NAME OF PROPOSED DEVELOPMENT HARDWARE / CONSTRUCTION MATERIALS

SITE PLAN REVIEW

PLAT REVIEW

Re: Ed-Rich Development Lumber Yard
I-30 and High School Drive
Phase I Lot

① SITE PLAN
SC. 1" = 40'-0"

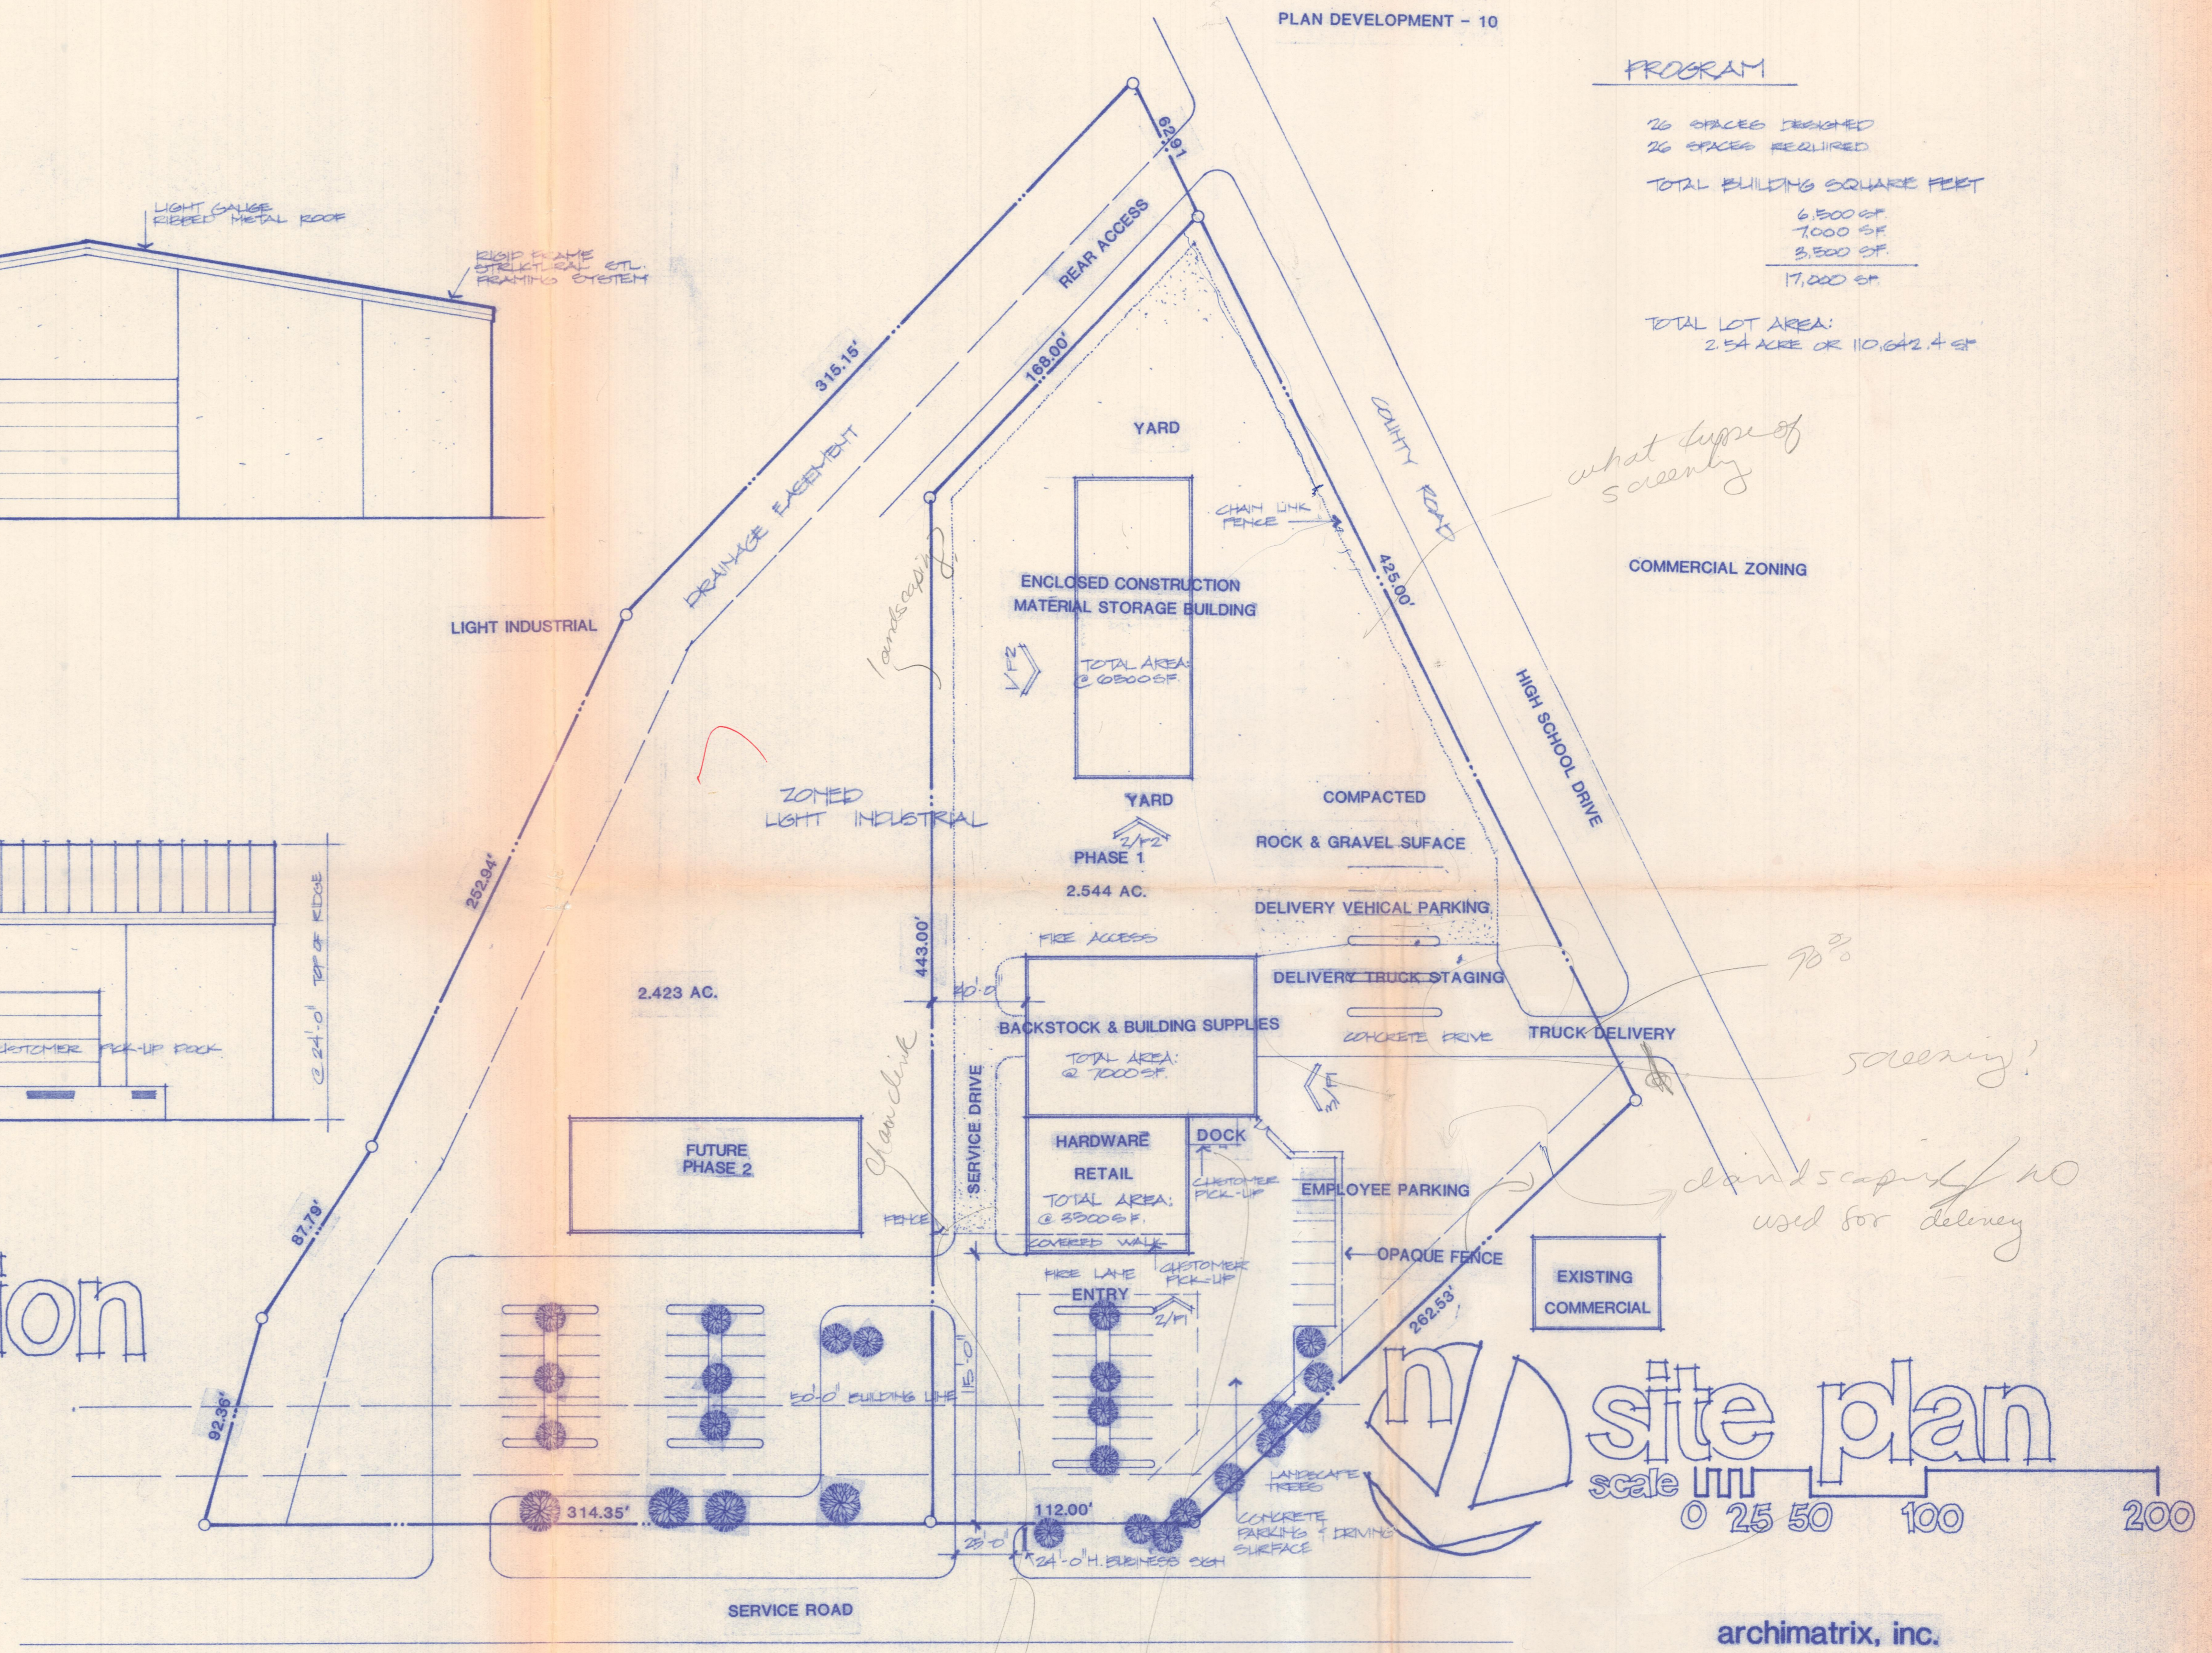
what satz fence
metal door?
radius? no of parking spaces

still need 28500 landscaping

what type of screening?

screening?

landscaping NO used for delivery

1 SITE PLAN
 SC. 1/4" = 1'-0"

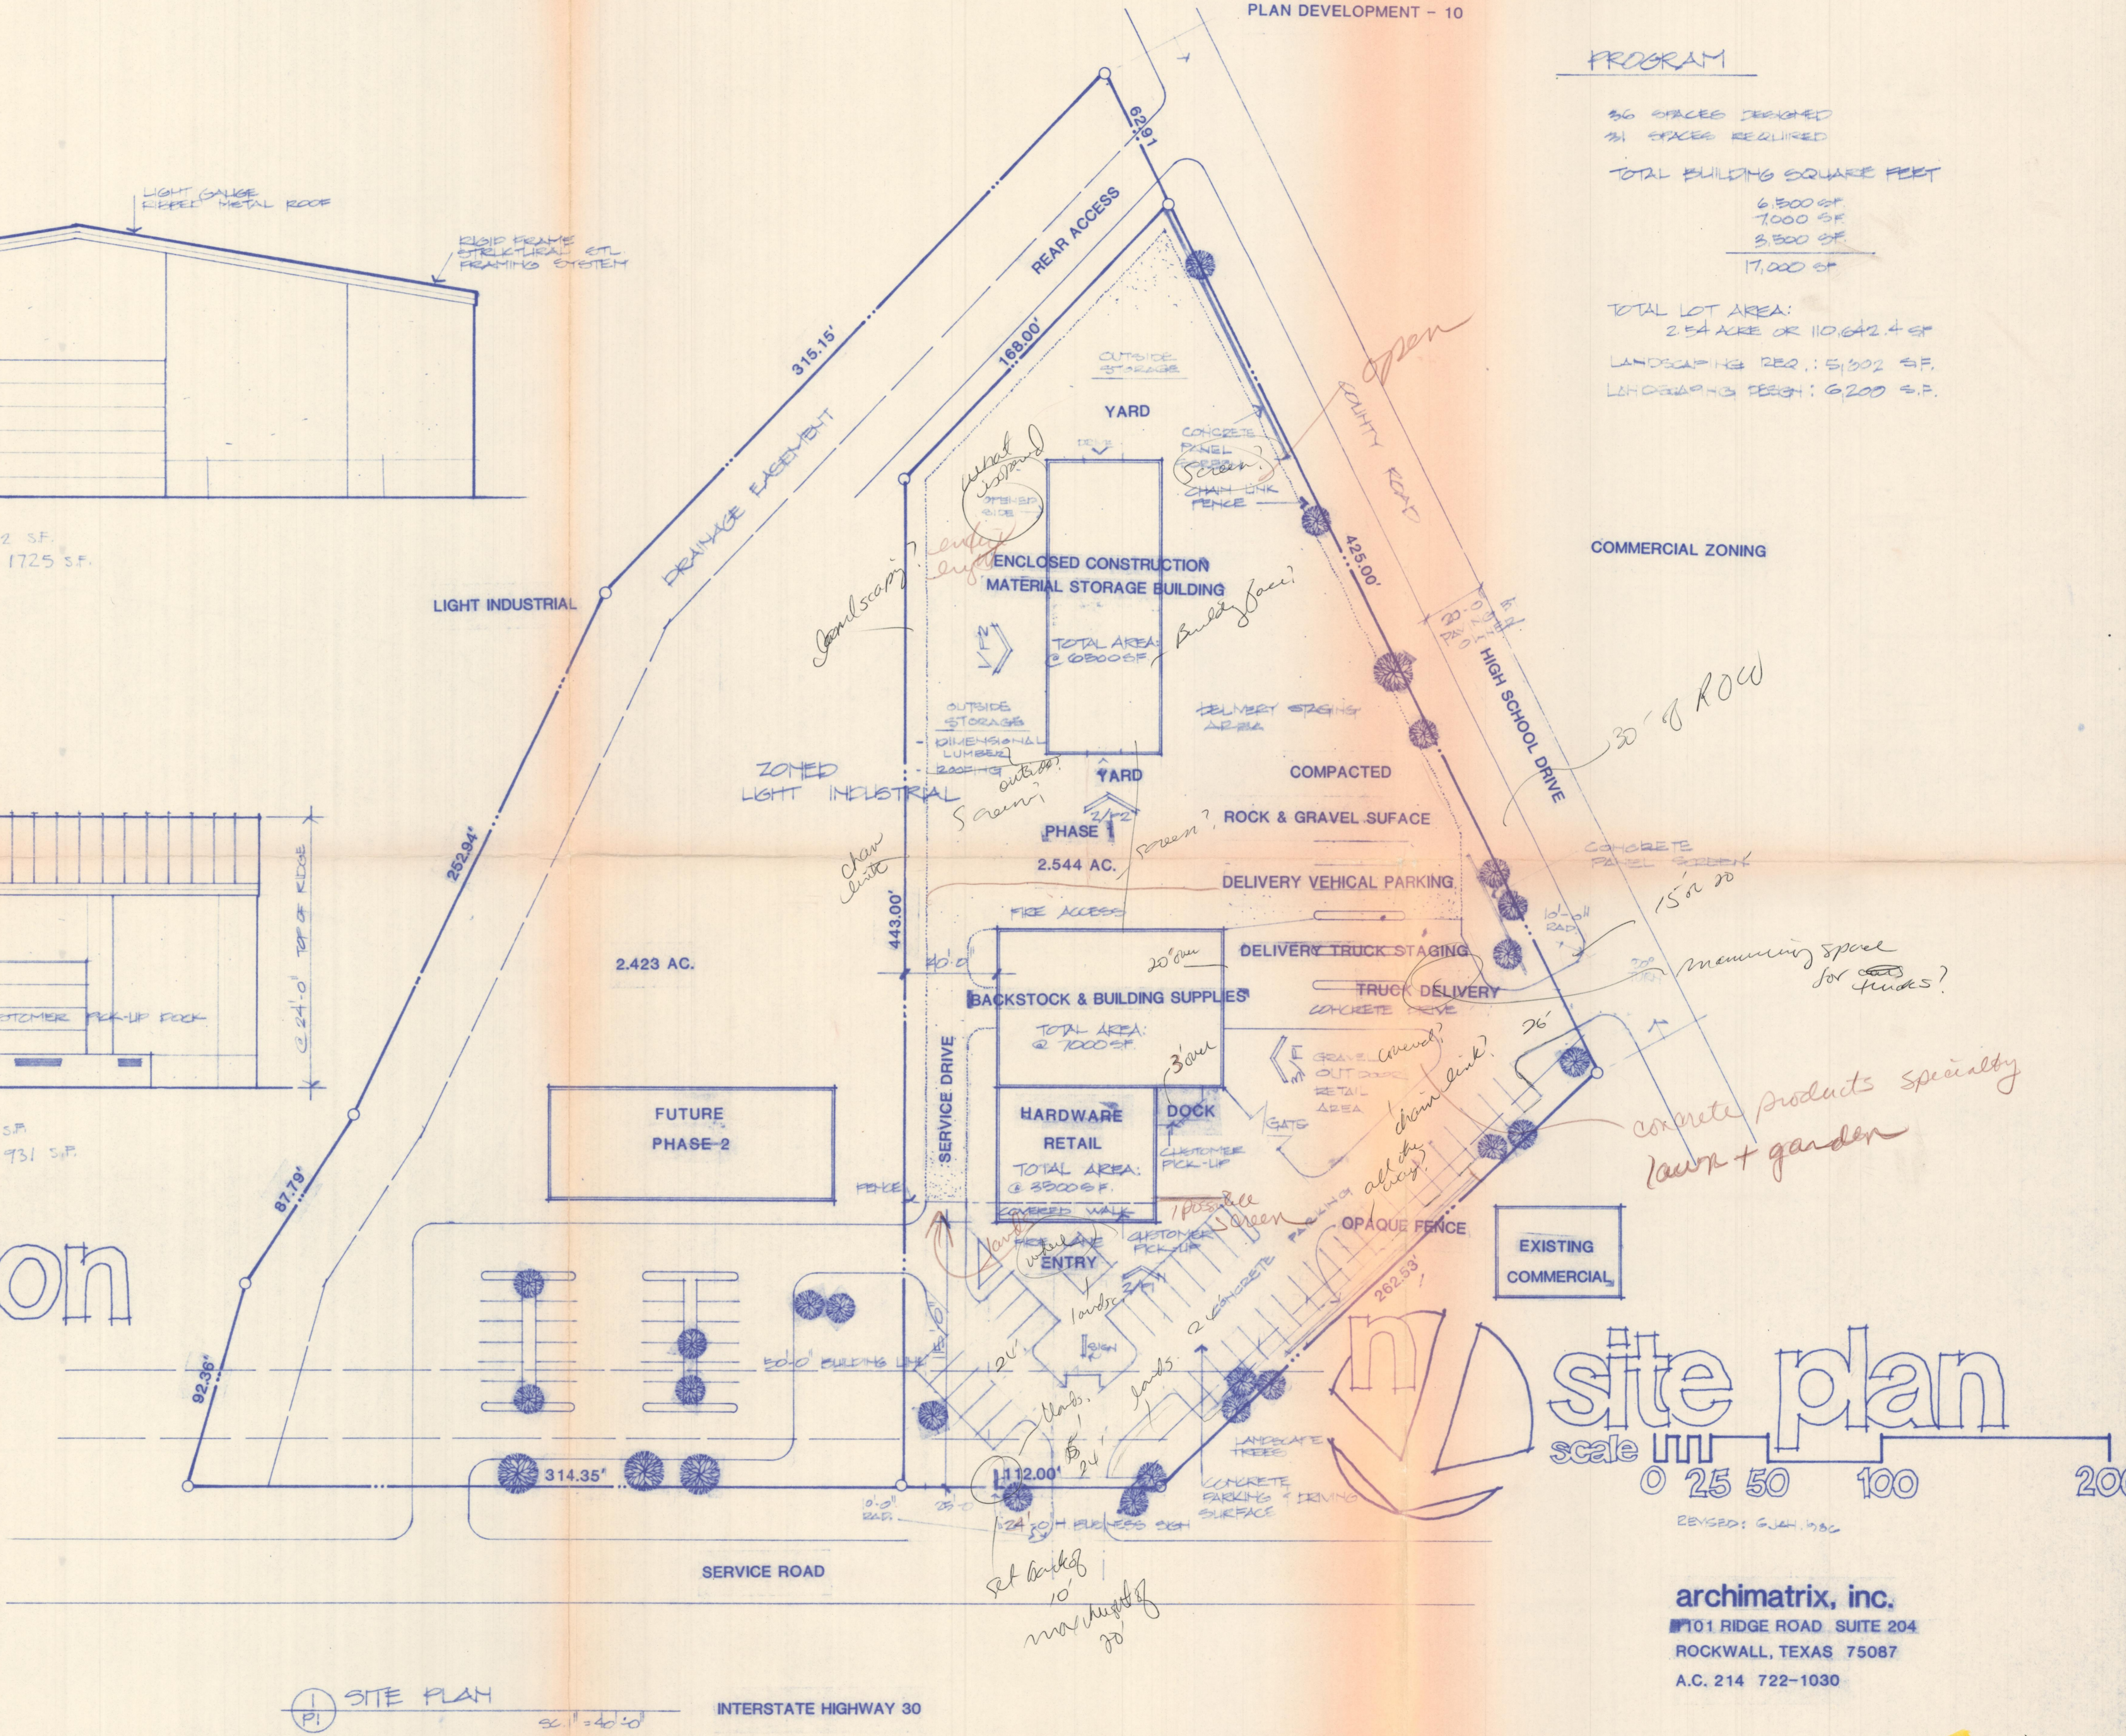
In regard to the subject above, I need 4 copies of the revised site plan showing the outside storage beginning at the front building line of the back building.

site plan
 scale 0 25 50 100 200
 REVS: G.J.H. 1/24
